## DEVELOPMENT REVIEW COMMITTEE (DRC) COMMENT REPORT

**PROJECT NAME:** 637 Art Lofts

**CASE NUMBER:** R18037

**REQUEST:** Site Plan Level II Review: 9 Multifamily Residential Units in Downtown

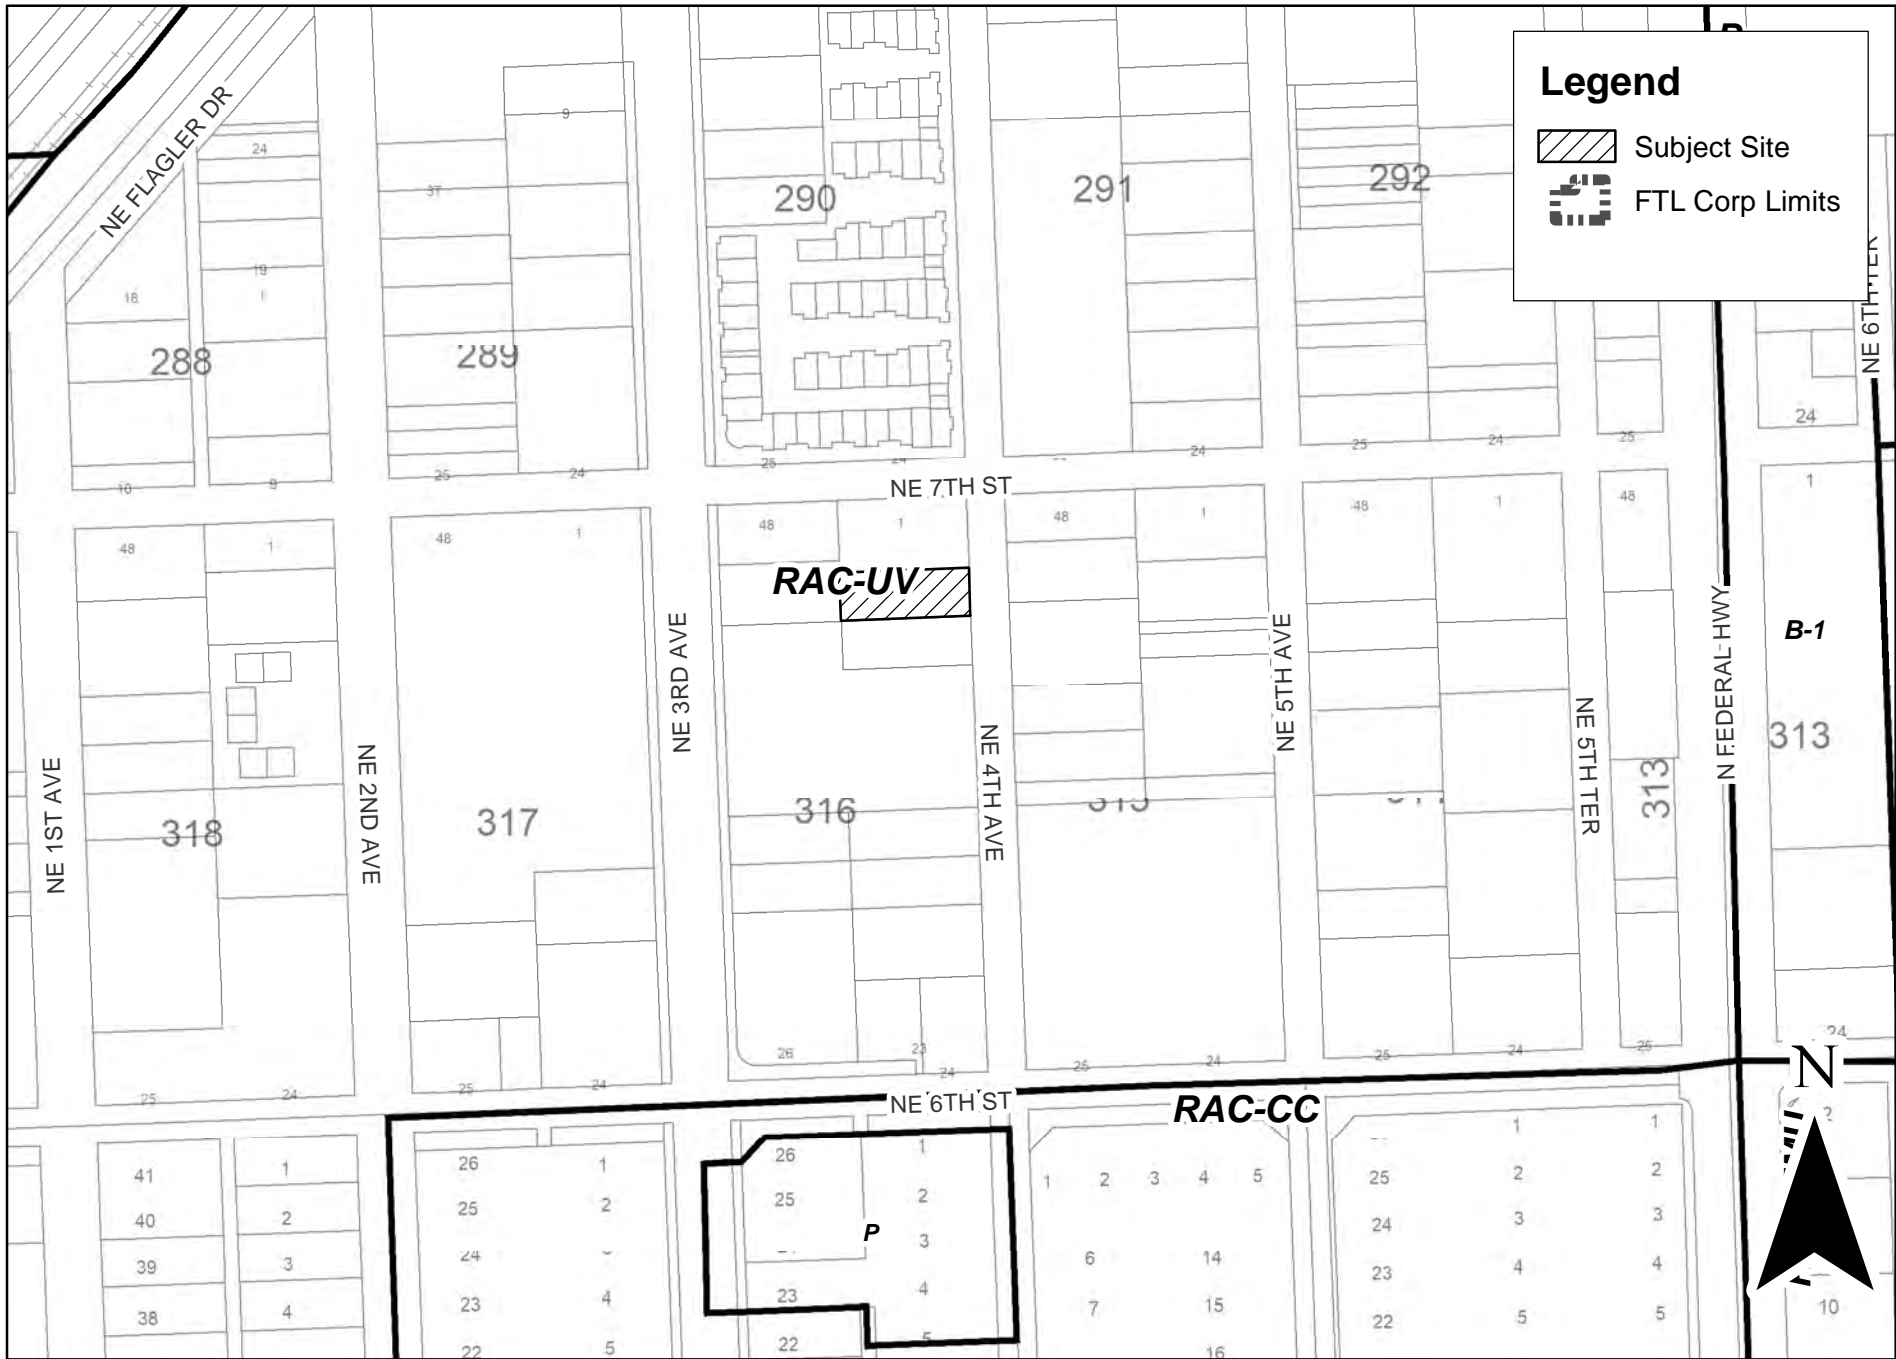
7. Provide the following changes on site plan:
  - a. Depict the approved site plan for the north (Flagler Townhomes project) and coordinate landscaping and FPL equipment along the joining property line;

- b. Consider removing the parking stall along the west property line and replace it with the FPL box;
  - c. Clarify the functionality of the alley; consider one way movement with ingress to site from NE 4<sup>th</sup> Avenue and egress to the alley;

- d. Demonstrate compliance with local street section as provided in the Downtown Master Plan; building line shall be located 35 feet from the center line of the street;

- e. Indicate all utilities (above and below ground) that would affect the proposed planting or landscaping plan. Overhead lines, if any, should be placed underground. If lines cannot be placed underground provide documentation from FPL;
